Your ref: Docket No. 71-9239 Our ref: UAM-NRC-06-012

August 29, 2006

SUBJECT: Docket 71-9239, License Renewal Application for Certificate of Compliance No. USA/9239/AF, MCC-3, MCC-4. and MCC-5 Packages

SHEET 1

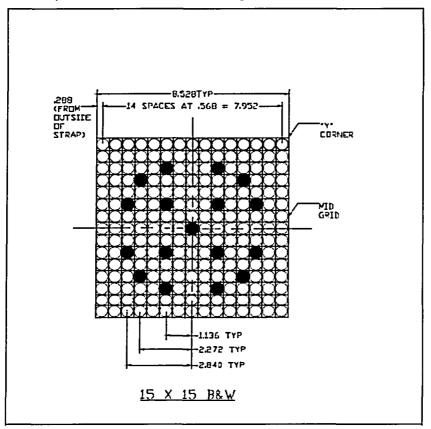
Westinghouse Drawing No. 6481E15 is revised to show the correct parameters for 15X15 B&W fuel assembly type. This change was previously approved by NRC letter dated September 27, 2004, Docket No. 71-9292, TAC No. L23765. Westinghouse Engineering Change Notice (ECN-0000378) is being processed to revise the product drawing as described below. The drawing is included in the application as fuel assembly cross sectional views in Appendix 1-3 Container Drawings. The revised drawing will be provided as an addendum to this renewal application

1. Near Zone D6/D5, replace the 15 X 15 GPU/B&W fuel assembly loading pattern with the pattern shown below including the technical title.
